DIRECT TESTIMONY
OF
HYDE M. MERRILL
ON BEHALF OF
THE SIERRA CLUB
BEFORE THE
STATE CORPORATION COMMISSION OF VIRGINIA
CASE NO. PUE-2009-00043

Figure 1
Highlighted lines indicate the areas of alleged 500-kV overloads relevant to PATH.

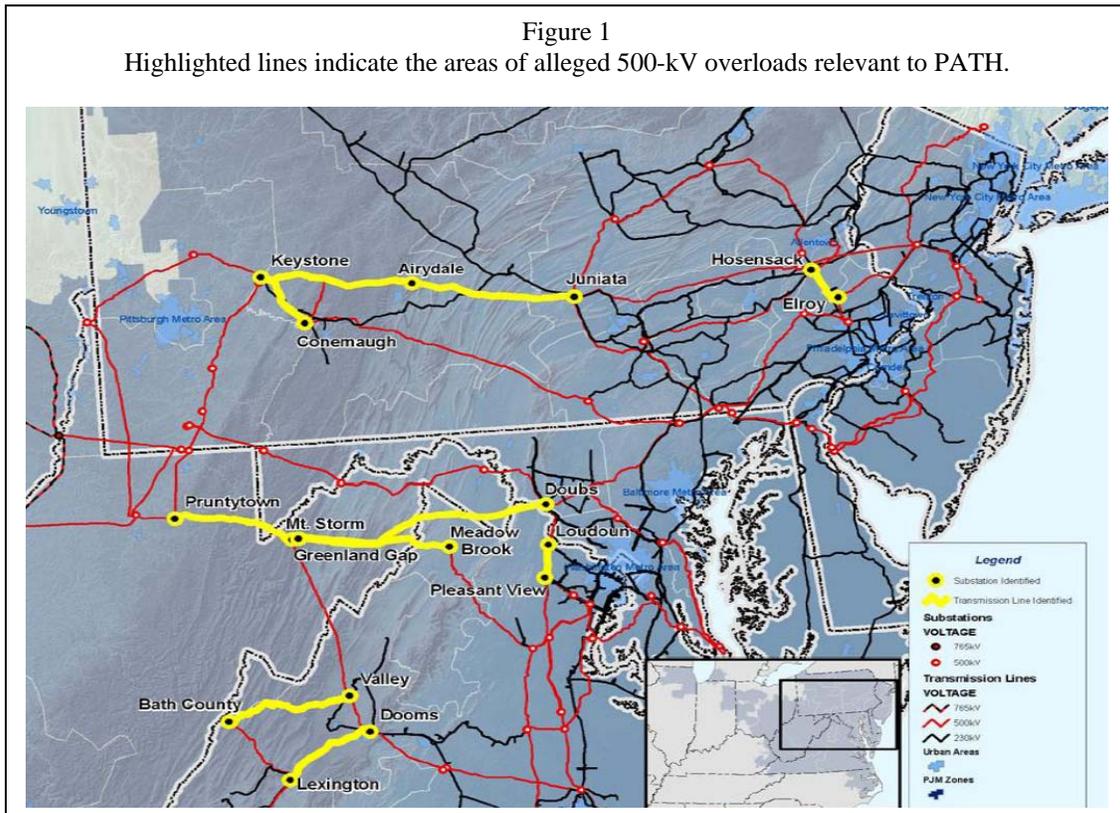
3 Q: PLEASE TRACE THE EVOLUTION OF THE ALLEGED 500-KV OVERLOADS.

4 A: Figure 1 and Table 3.4, both from the 2007 RTEP, will be helpful in following the
5 discussion below.

1 In 2006, a PJM analysis concluded that with the [TrAIL] line, the only overloads relevant
2 to PATH would be on three 500-kV lines in central Pennsylvania, in 2019 and 2020.

3 In areas most relevant to PATH, the 2007 TEAC report said that Pennsylvania overloads
4 would now occur in 2012 (the 5th year) and 2013 (an extrapolated year). In addition, overloads
5 were projected on lines near Mt Storm and elsewhere in Virginia, notably Bath County. The
6 claimed 2012 overloads were two Keystone lines (Pennsylvania) and the Mt Storm-Doubs line.
7 Although these were five years out, applications for projects to relieve these alleged overloads
8 were not filed.

9 In the 2008 RTEP report, the need for PATH was projected to be in 2013, one year later
10 than in the 2007 RTEP report. The alleged violations in the 5th year (2013) continued to be
11 thermal overloads of the Mt Storm-Doubs line and of lines in Pennsylvania in the same area as
12 those identified in the 2007 RTEP report. In the extrapolation region were more Pennsylvania
13 and Virginia lines, including lines in the Bath County system as well as lines near Washington,
14 DC.

15 In the April 2009 study, there were no claimed thermal overloads in the 500-kV system in
16 2014, the 5th year. They all occurred in the extrapolation years, beginning in 2015 and 2016.
17 The earliest claimed overloads were of the Mt Storm-Doubs line and of a line in the Bath County
18 system. The Pennsylvania thermal overloads began next.
